# Leland Reservoir Replacement Project Final Environmental Impact Report

## Volume III – Responses to Comments

SCH #2016082082

Volume III

LELAND RESERVOIR - FINAL EIR  
EAST BAY MUNICIPAL UTILITY DISTRICT  
1040 LELAND DRIVE | POST-CONSTRUCTION  
JUNE 2018

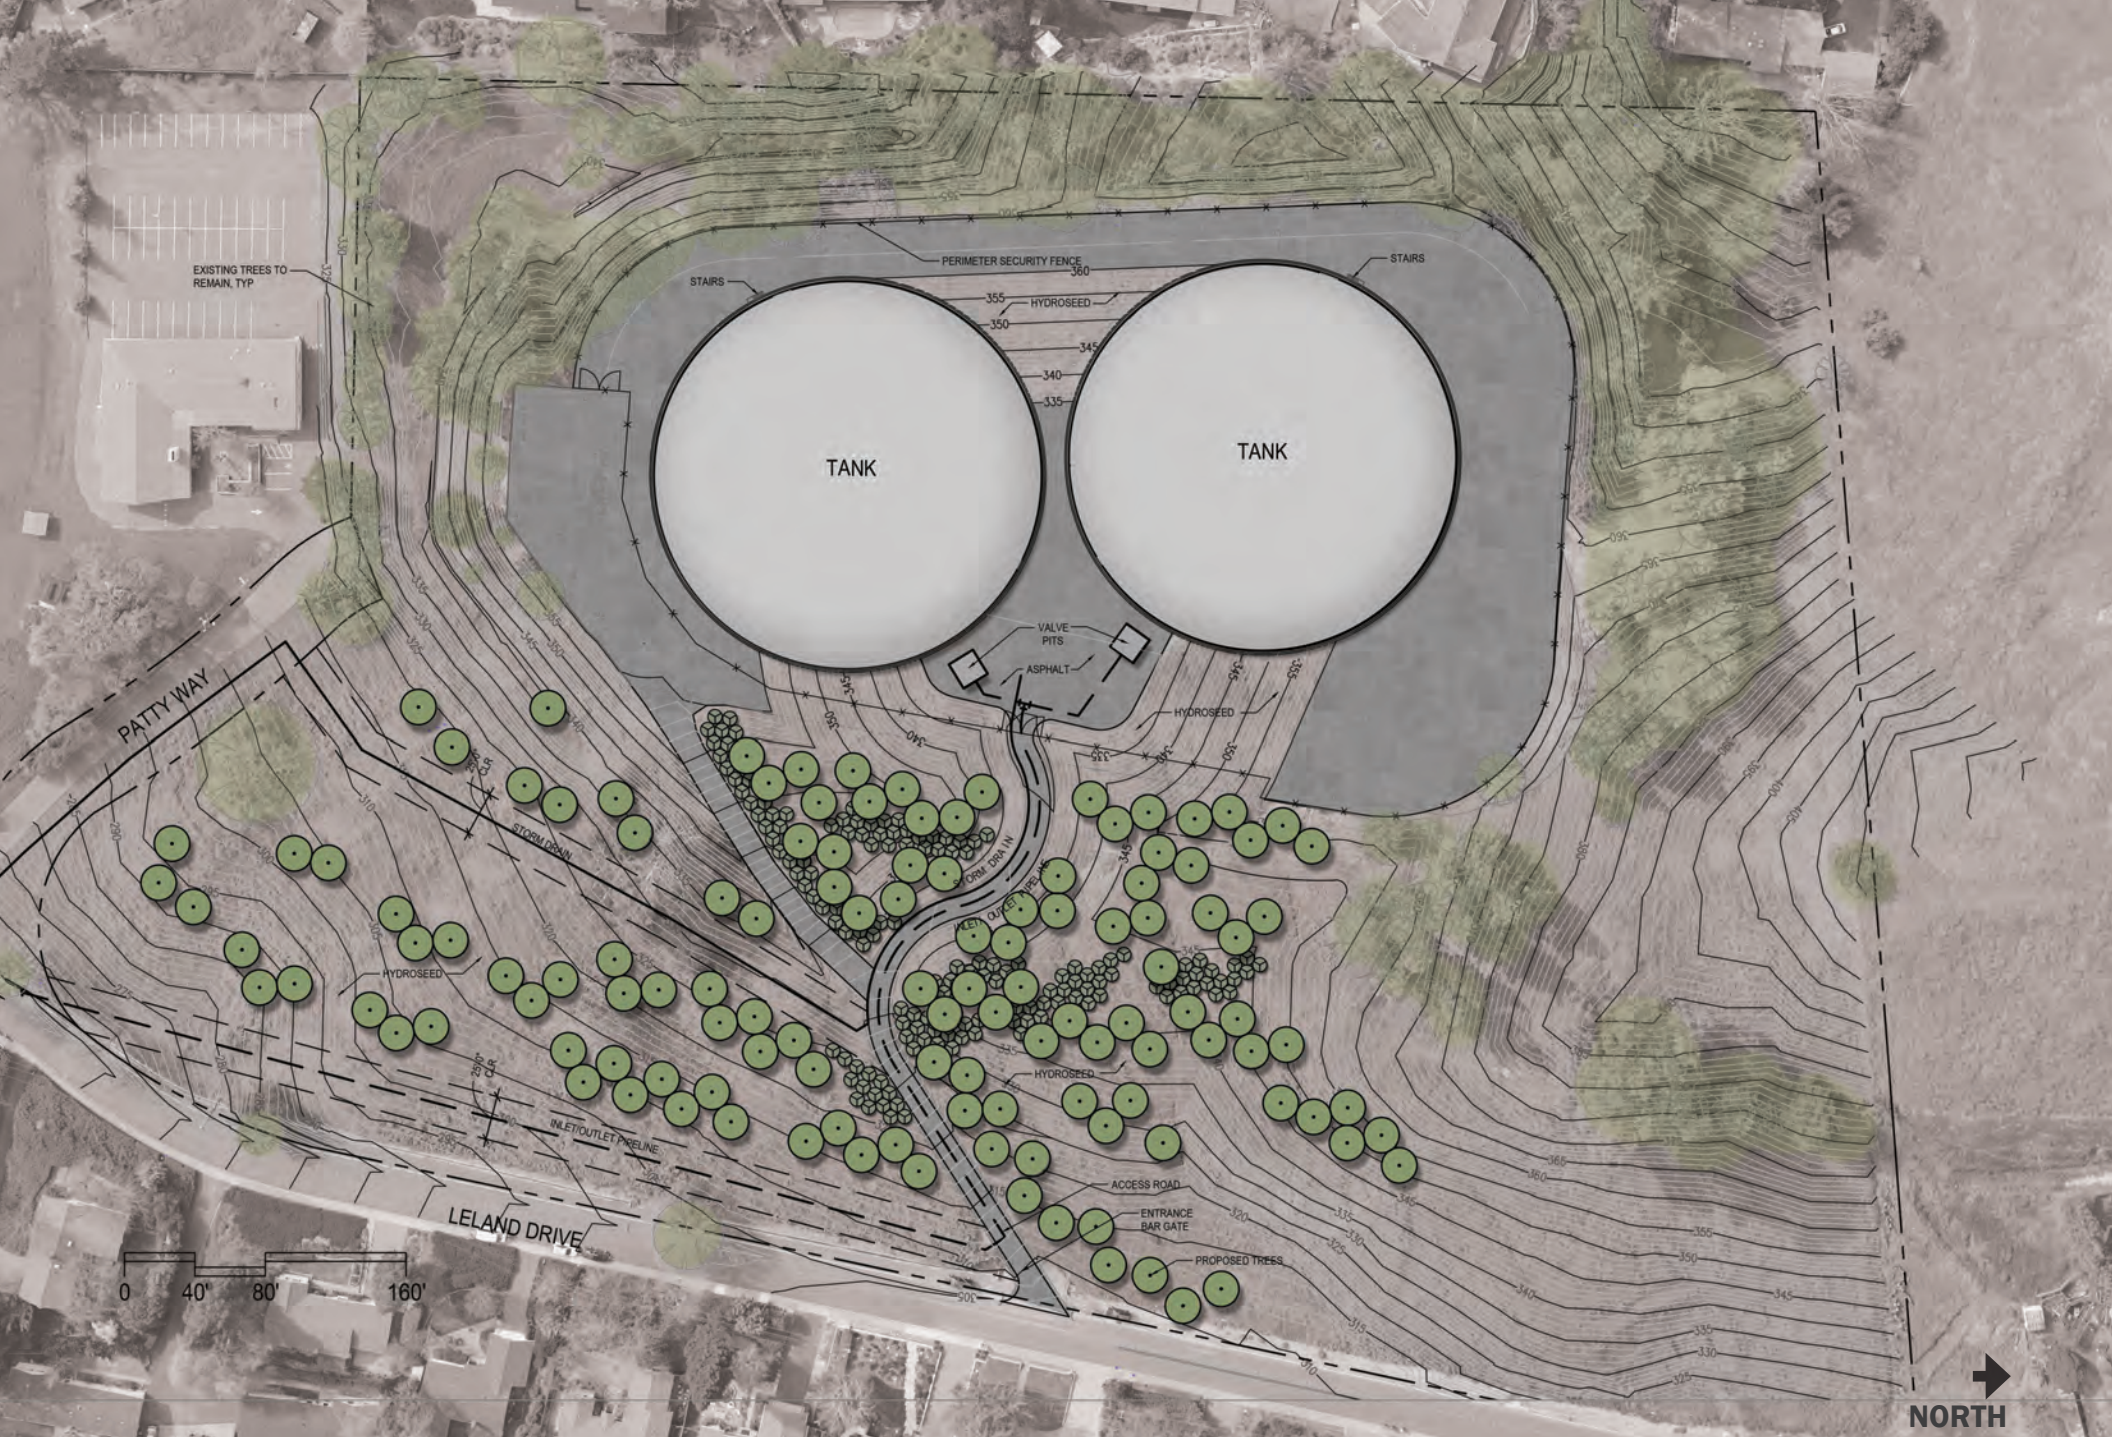
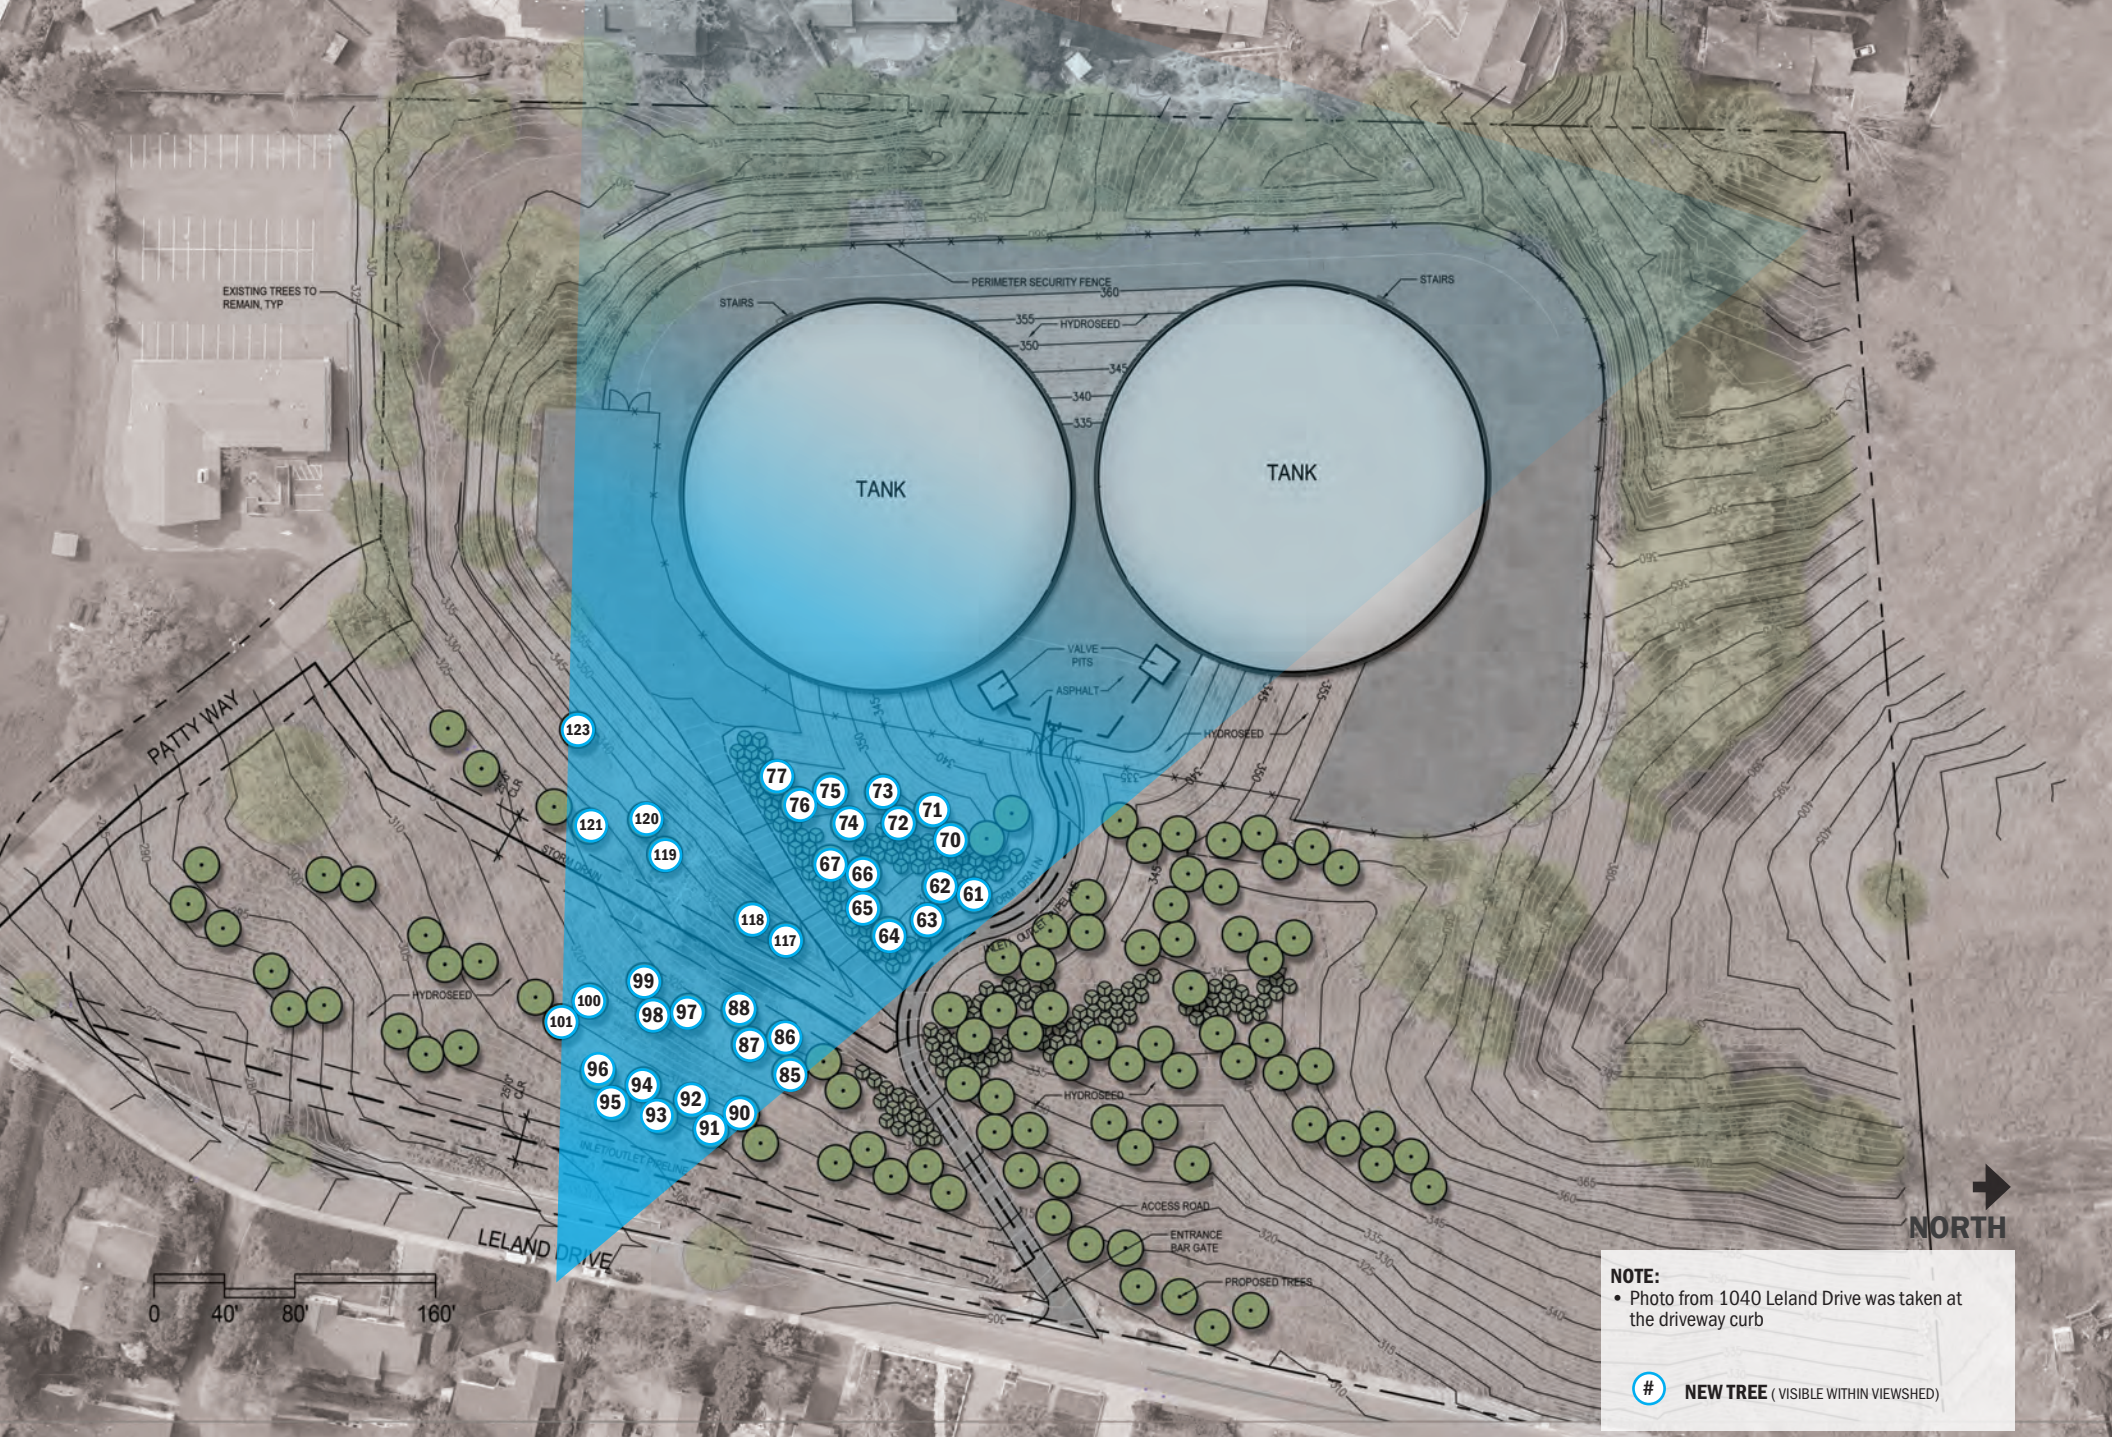
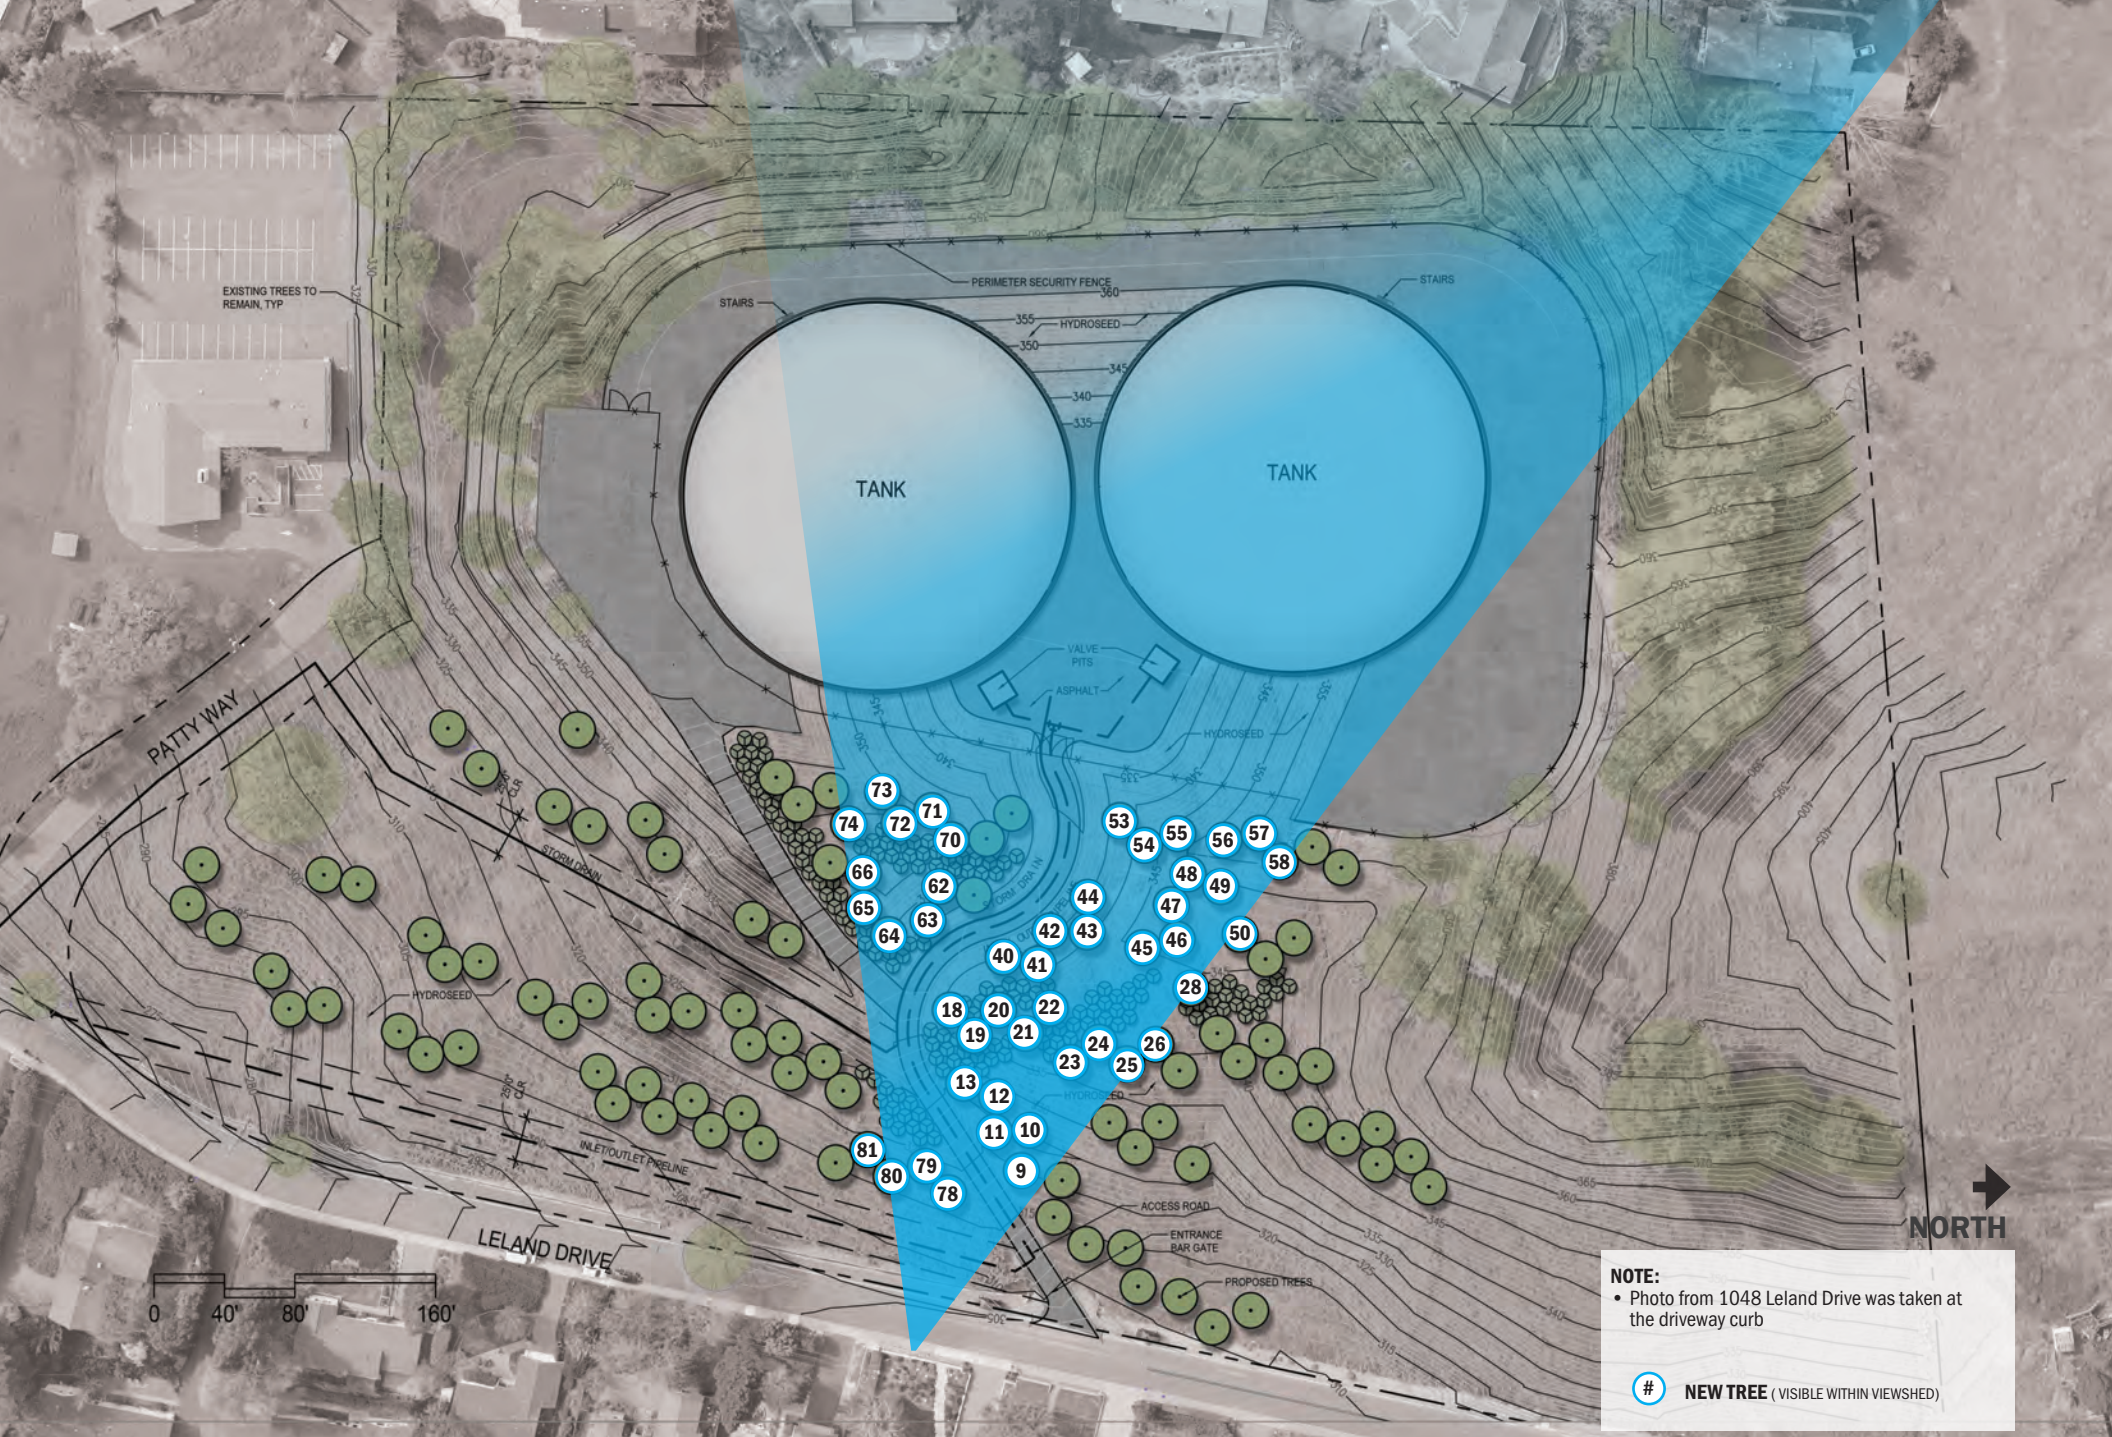
Comments from neighbors included some specific requests for viewpoints along Leland Drive. Visual simulations showing the revised landscape plan are provided for all three of the viewpoints depicted on pages 3.1-9 through 3.1-11 in the Draft EIR for 1040 Leland Drive, 1050 Leland Drive, and 24 Ruth Court. The Draft EIR included photographic simulations from public viewpoints at 1040 Leland Drive and 1050 Leland Drive and a computer rendering of the simulated view from the private backyard of 24 Ruth Court. The revised simulation for 24 Ruth Court now includes a photographic simulation because the resident provided access to the backyard, enabling a more accurate representation of the view from the site than was provided in the computer simulated view. The reservoir and location for the proposed tanks is not visible from most of the backyard at 24 Ruth Court, so the viewpoint is from a portion of the yard that is not typically used for outdoor gatherings. Photographic simulations of two additional viewpoints have also been included: 1401 Sunset Loop and 1048 Leland Drive. The view from the backyard of 1401 Sunset Loop provides another simulation from a higher elevation. The view from 1048 Leland Drive looks directly west at the point where the entrance road would enter the tanks as requested in comments

from Leland Drive residents. To address concerns about how the reservoir site would look immediately after construction, additional visual simulations are included to show the Project appearance immediately post construction, five years after construction, and fifteen years after construction.

The following new and updated visual simulations are included in the Final EIR at the end of this Master Response:

- 1040 Leland Drive (updated from Figure 3.1-2 in Draft EIR) – post construction, 5-year projection, 15-year projection
- 1048 Leland Drive (new view directly west to entrance road) – post construction, 5-year projection, 15-year projection
- 1050 Leland Drive (updated from Figure 3.1-3 in Draft EIR) – post construction, 5-year projection, 15-year projection
- 24 Ruth Court (updated from Figure 3.1-4 in Draft EIR) – post construction, 5-year projection, 15-year projection
- 1401 Sunset Loop (new view from backyard of adjacent residence) – post construction, 5-year projection, 15-year projection
